SOUTH LAKE UNION **BLOCK 57 WEST** 300 DEXTER AVENUE NORTH

WEST DESIGN REVIEW BOARD
SEATTLE DCI #: 3025418
DESIGN REVIEW BOARD RECOMMENDATION MEETING: APRIL 17, 2019

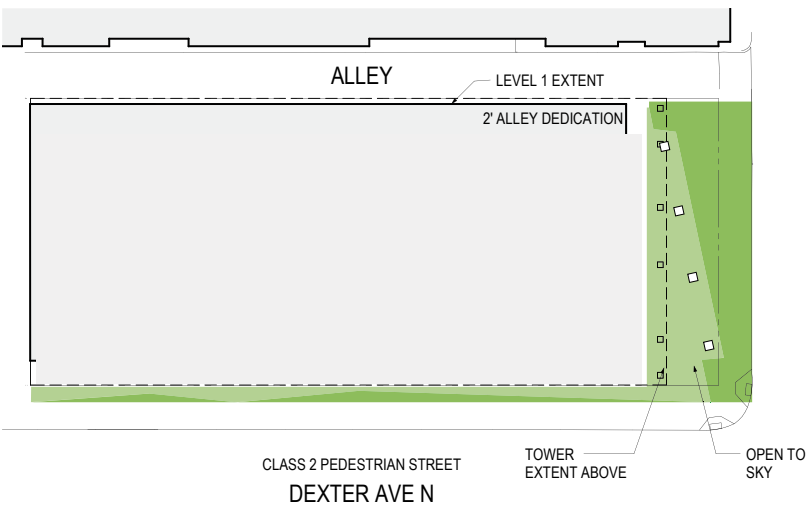
- A. The Board agreed that the ground floor scale should be taller than shown on pg 49, and with a greater setback from the street, especially at the southwest corner. (CS2-C.1)

- B. The Board supported the depth and extent of retail shown [49] and recommended multiple doors that would activate the plaza and Dexter frontage. (CS2-A, PL3)

- Multiple doors provided to plaza and Dexter frontage.
- C. The Board strongly supported the deep and continuous open space along Thomas Street as shown on 48/middle, and recommended more depth of setback along Dexter, possibly using a folded/creased motif from the tower above. (PL1-A, DC3-I)

- Agreed. The ground plane setback increased along both Dexter and Thomas. Additionally, the ground plane zone now includes both Levels 1 and 2 yielding a taller pedestrian level.

- Agreed. The ground plane setback increased along Dexter and Thomas. The southwest corner is further setback by canting the façade along Dexter, similar to the walls above.

LEVEL 01 PLAN -PROPOSED DESIGN

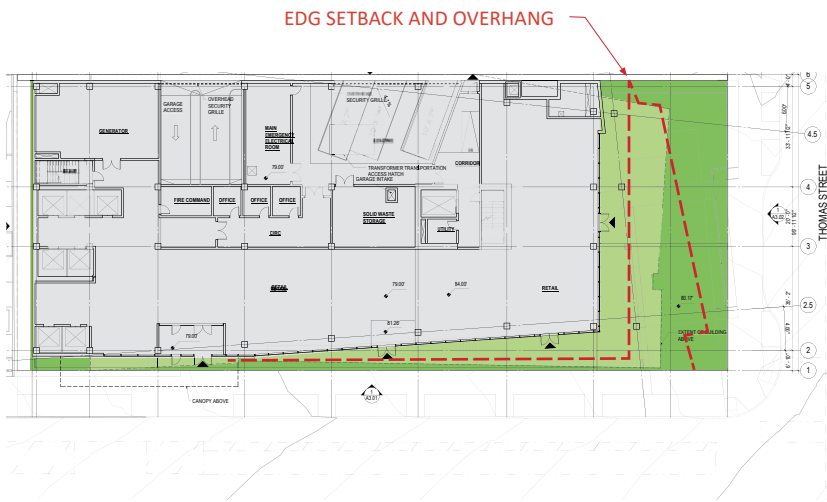
- Bicycle parking is proposed near the main entrance on Dexter.
- F. The Board agreed that the increased setbacks and scale of the lower levels is critical, as well as the legible modulation above, and any 'lost floor area' can be made up in a taller form. (CS2-B)

- The ground plane zone (Levels 1 and 2) is further set back and the form responds to the form of the volumes above. The floor area pulled from these levels is captured on Level 11.

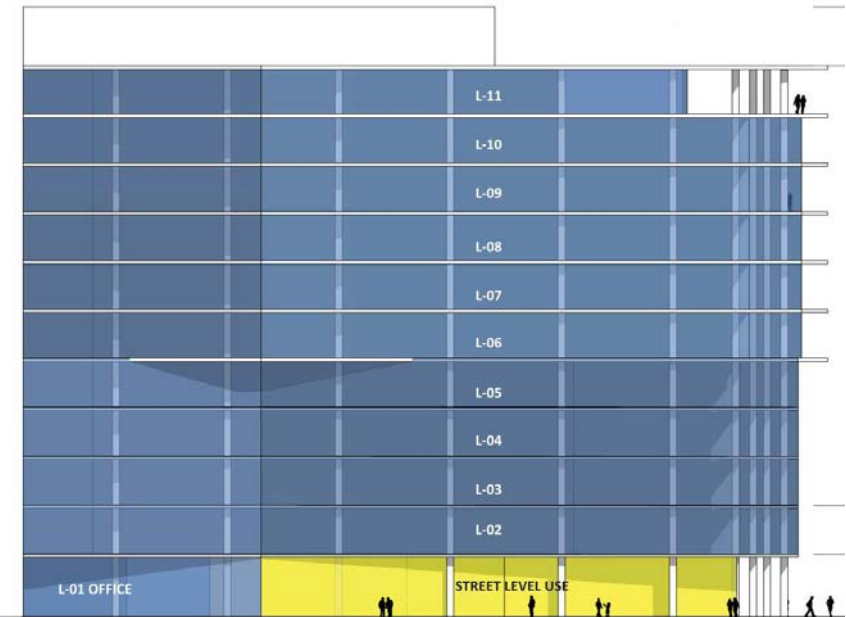
D. The Board recommended the proposed Dexter façade acknowledge the mid-block view axis from the project across Dexter Avenue, although it may be a subtle gesture. (CS2-B)

The mid-block view axis across Dexter is acknowledged with the main building entrance and play of glass facades above, anchored by the masonry element on the north end of the building.

GROUND LEVEL PLAZA - PROPOSED DESIGN

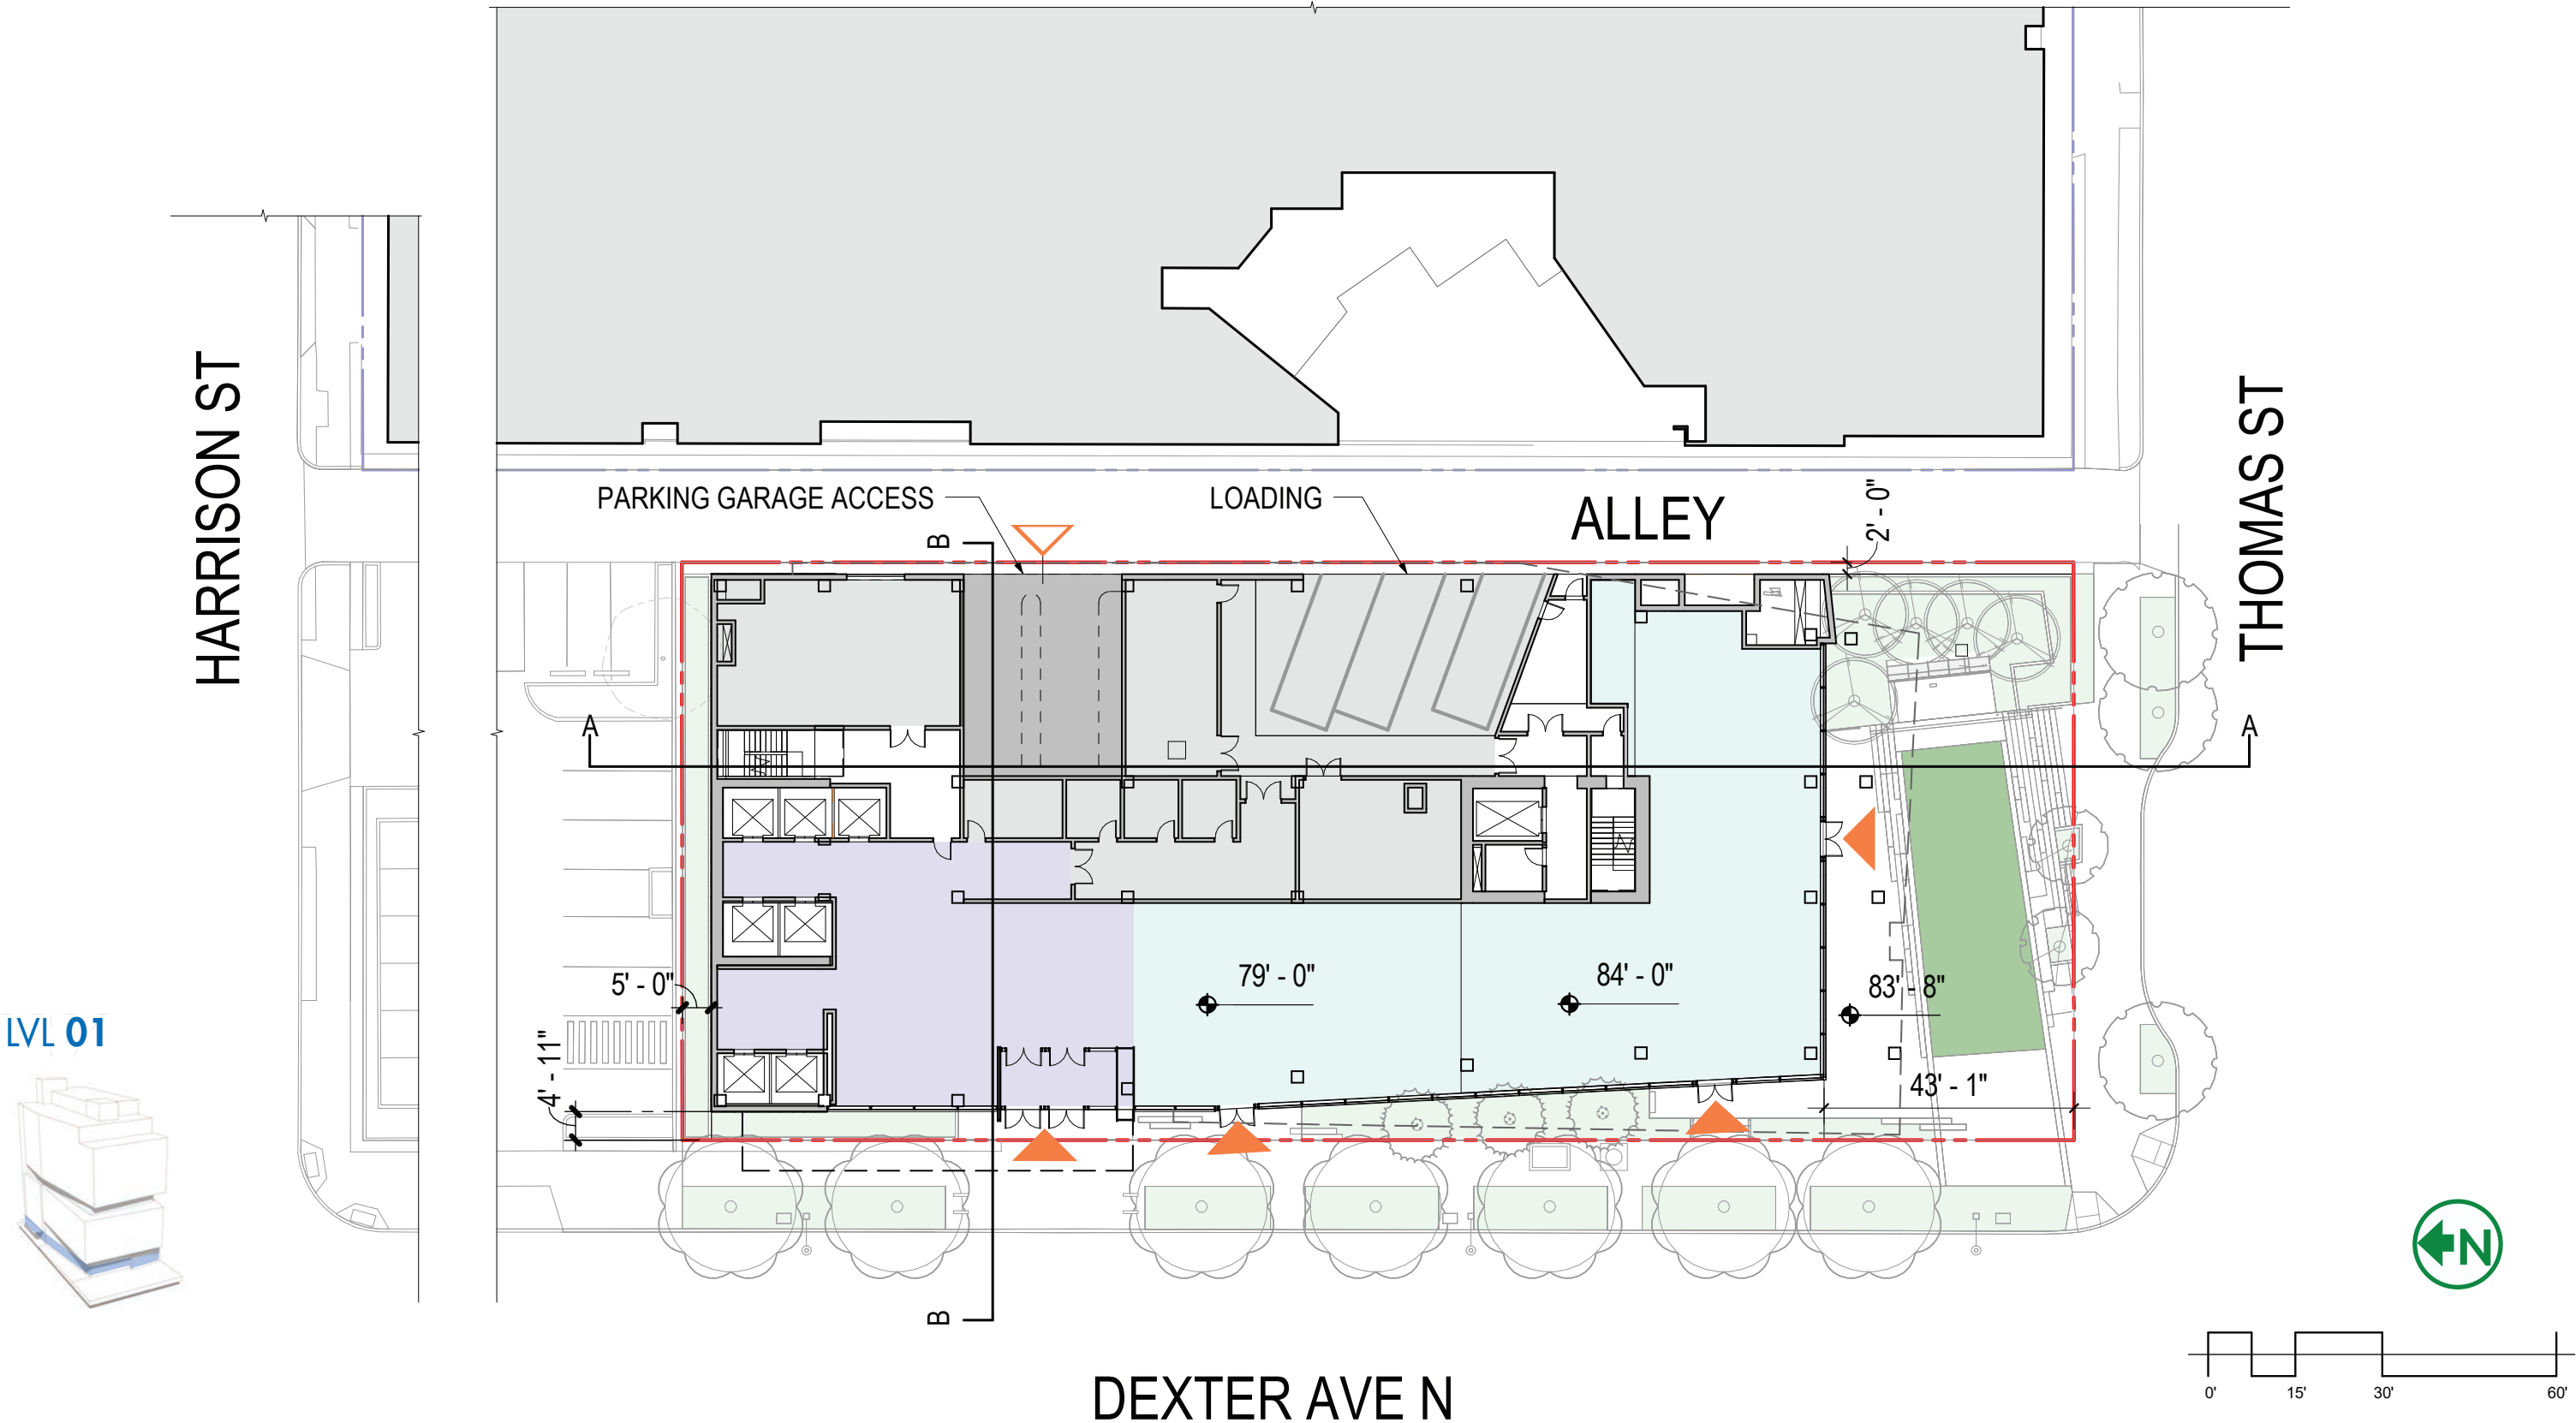
E. The Board supported integration of green walls, but concurring with public comment, recommended irrigation and detailing to ensure the green walls thrive, and the underlying architecture is complete in case the vegetation is slow to grow or does not survive. (DC4-D)

Rich, sustainable plantings on the landscaped terraces and around the ground-level plaza provide the primary visual emphases along the Thomas Green Street.

DEPARTURE PODIUM FLOOR AREA LIMIT

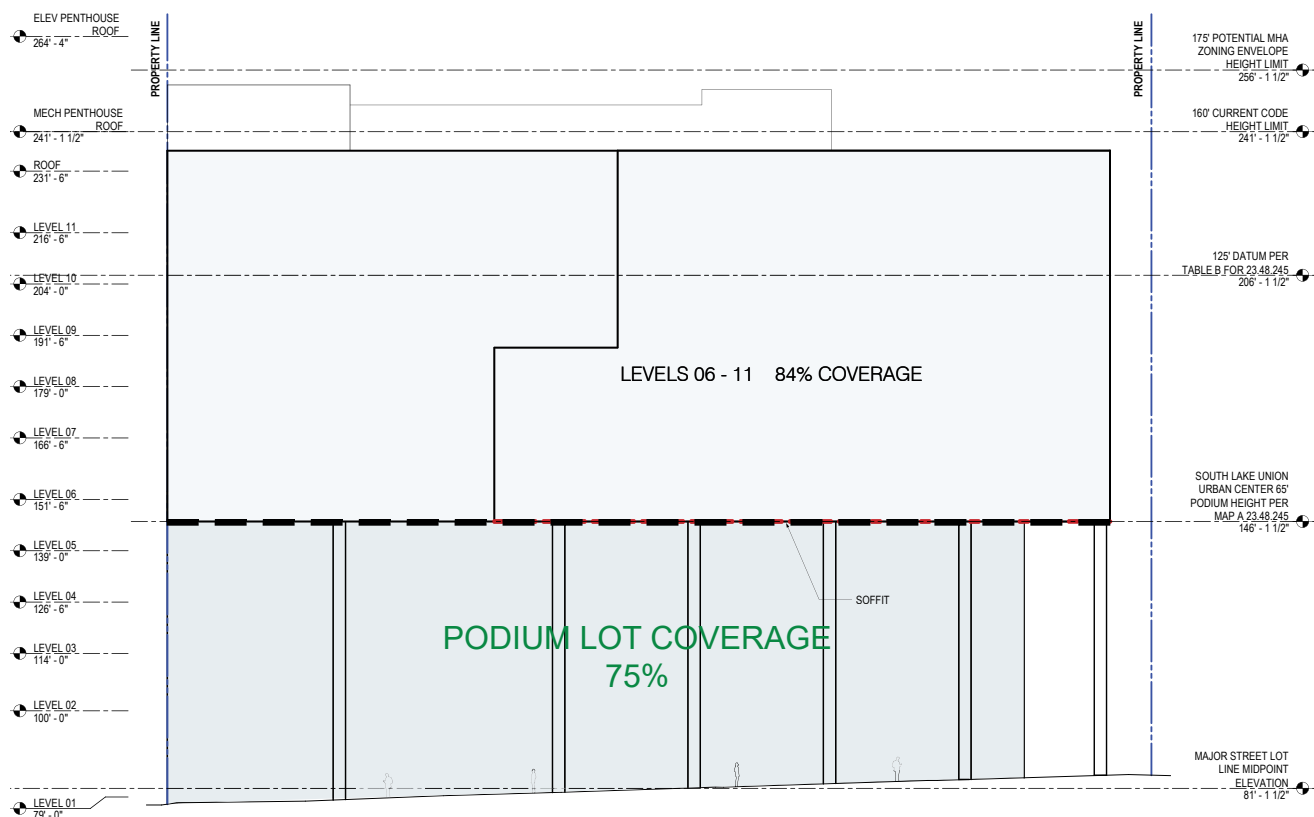
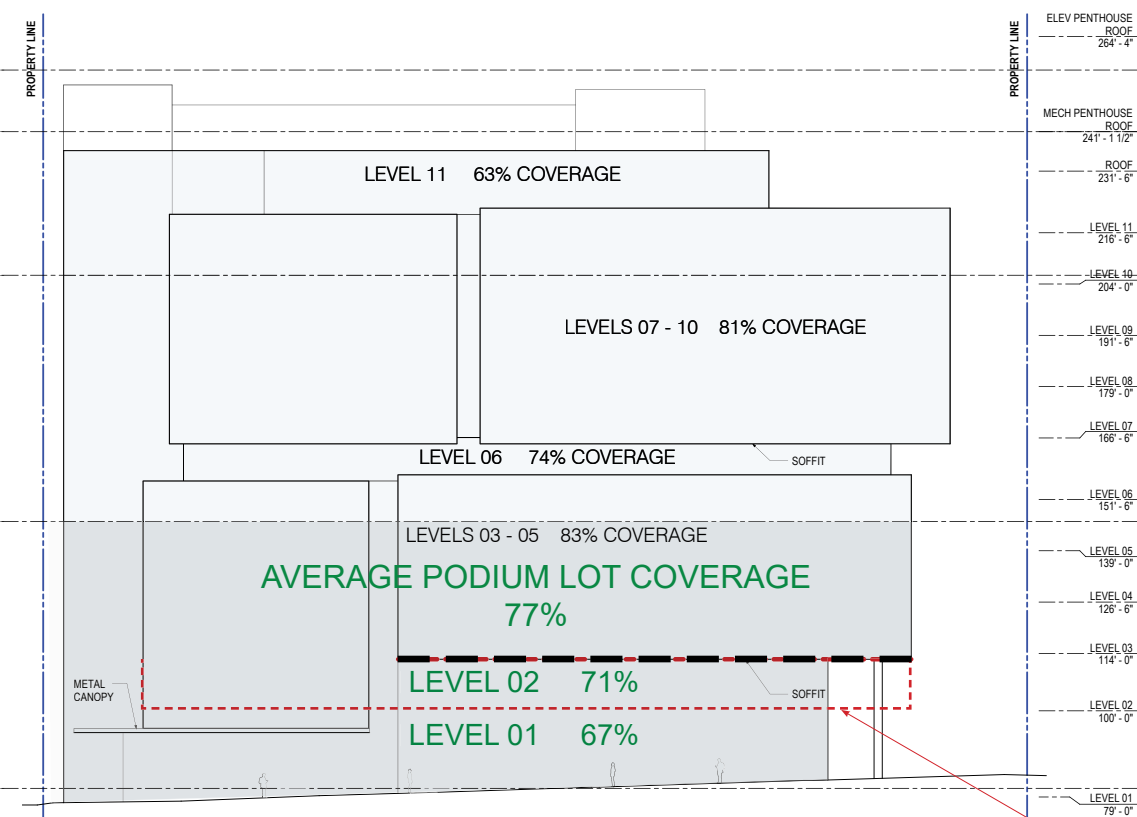
The proposed design seeks a departure to exceed the average podium lot coverage limits established in SMC 23.48.245.B.4.b by 2 percent for an average podium lot coverage of 77 percent.

On this small lot size of 23,980 SF, the resulting massing of the code requirement yields an uncomfortable pedestrian-level environment with very tall, skinny columns supporting the large floorplates above. By averaging the podium floors (levels 01 - 05), we are able to reduce the footprint of levels 01 and 02, thus reducing the height of the soffit to a comfortable pedestrian-scale, and provide additional sheltered open space at ground level (PL2 - Walkability). The proposed design decreases the podium lot coverage on level 01 to only 67 percent and 71 percent on level 2 where the coverage will be experienced to the greatest extent by the pedestrian (PL1 - Connectivity, PL3 - Street Level Interaction & DC3 - Open Space Concept). This strategy permits us to increase the floorplates of levels 03 - 05 to support building massing which further breaks down building scale to complement neighboring buildings and context (CS2 - Urban Pattern and Form & DC1 - Project Uses and Activities). The average lot coverage for the overall building is 77 percent, even though 100 percent lot coverage is allowed at the tower levels. Voluntarily restricting the tower floorplates preserves the strong architectural concept that is expressed on levels 3 - 11 (DC2 - Architectural Concept).

DEPARTURE UPPER-LEVEL FACADE MODULATION

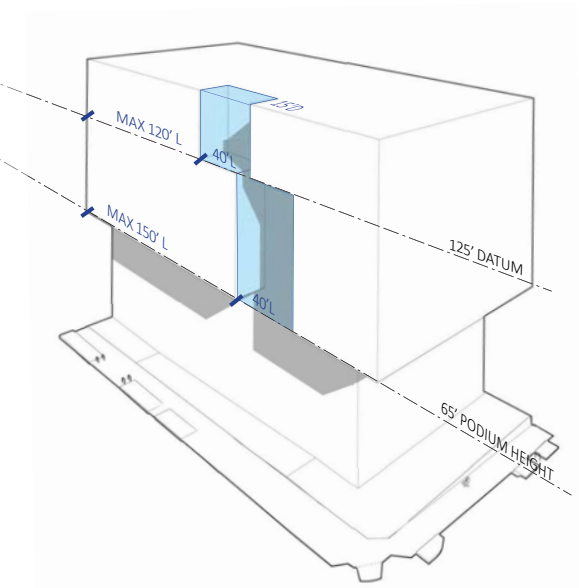
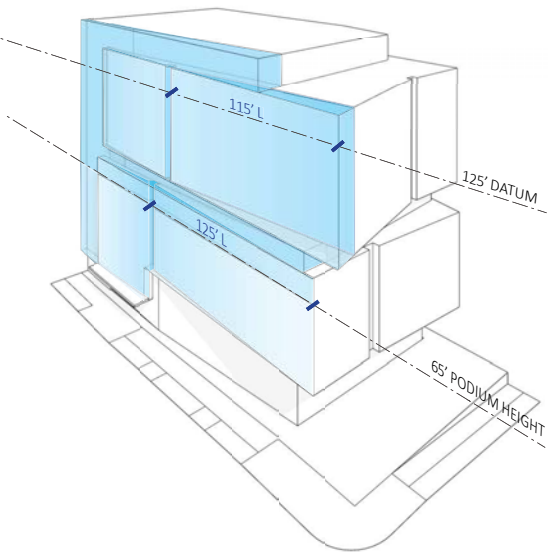
Provision limits the unmodulated facade length above the podium to 150 feet and above 125 feet to 120 feet in length, and establishes a 15 foot setback for 40 feet in length as the minimum needed to establish a break in the unmodulated facade.

The project takes a larger view than that prescribed by code. The prominence of the building corner at the intersection of Dexter and Thomas, and the desire for architectural interest of the south facade along the Thomas green street, leads us to big massing moves that wrap modulation around the south and east facades (CS2 - Urban Pattern and Form & CS3 - Architectural Context and Character). The resulting large volumes are independently modulated to create a dynamic three-dimensional composition that exceeds the code intent to break down building scale and create visual interest (DC2 - Architectural Concept). The proposal improves the viability of office floorplates on a very narrow site and reduces pressure to grow the building massing to the south, where solar and open-to-sky access benefits the open space along the Thomas green street (DC3 - Open Space Concept).
